Machine Service Bulletin No. 429-A

Model: LA LA-5 LA-6

SUBJECT: Plus and Minus Keys Action

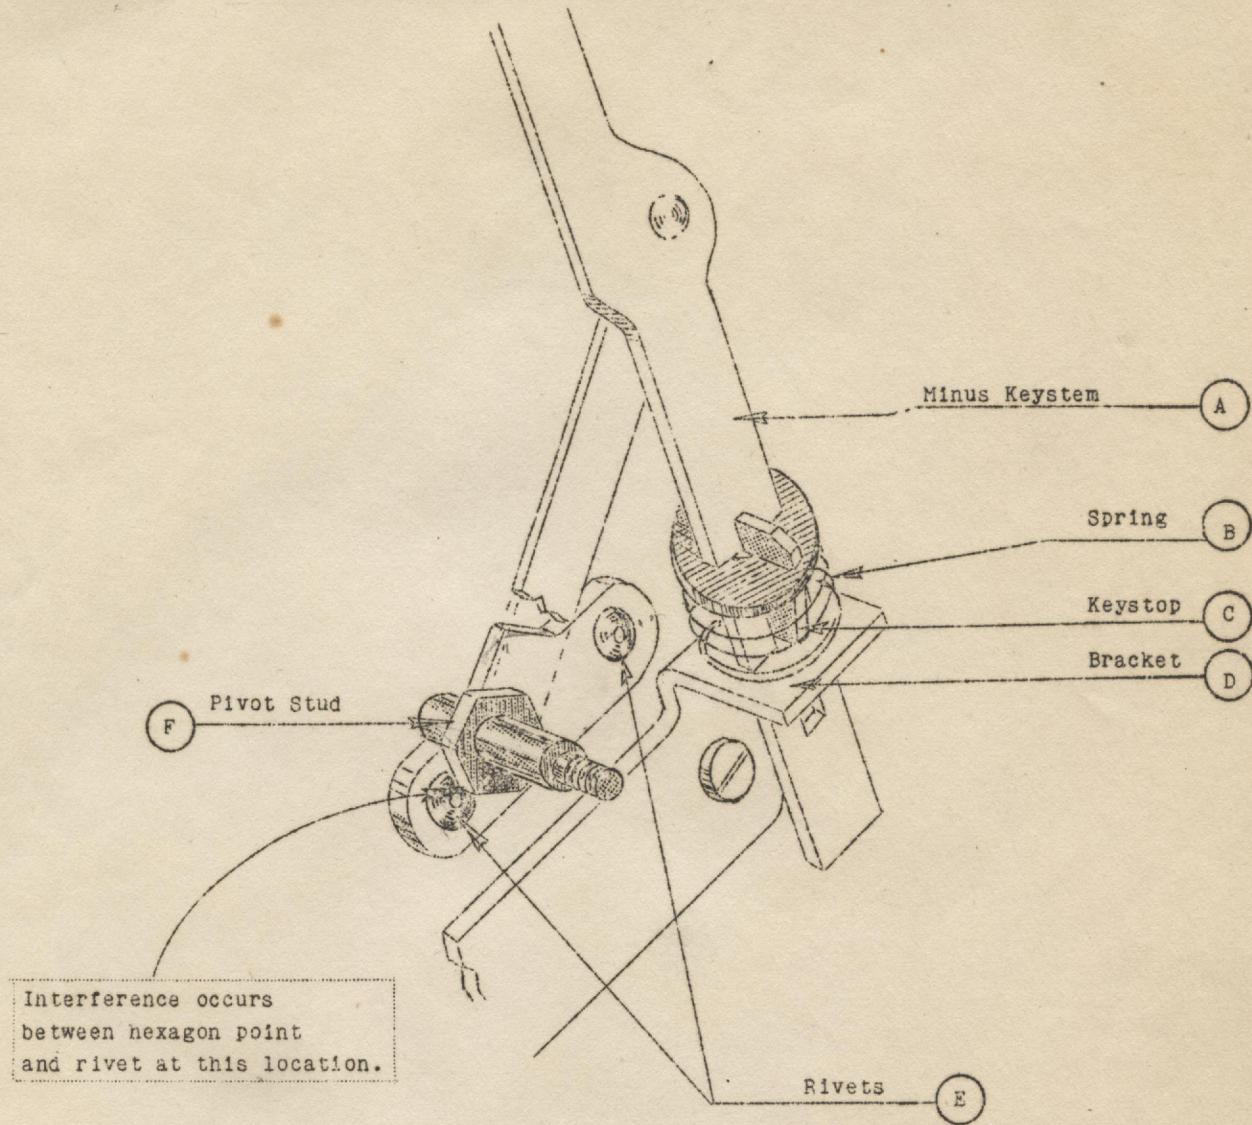
When installing the mechanism shown in Machine Service Bulletin No. 429, it is recommended that stock be removed from rivets (E) to prevent interference with pivot stud (F).

If a point of the hexagon on (F) should engage the head of (E), it is possible that depression of the plus or minus key could occasionally fail to fully move the clutch yoke into engagement with the transmission.

To determine if interference exists between (E) and (F) when either plus or minus key is depressed, lift spring (B) and note if keystop (Liberty Bell) (C) is limiting on bracket (D) as it should.
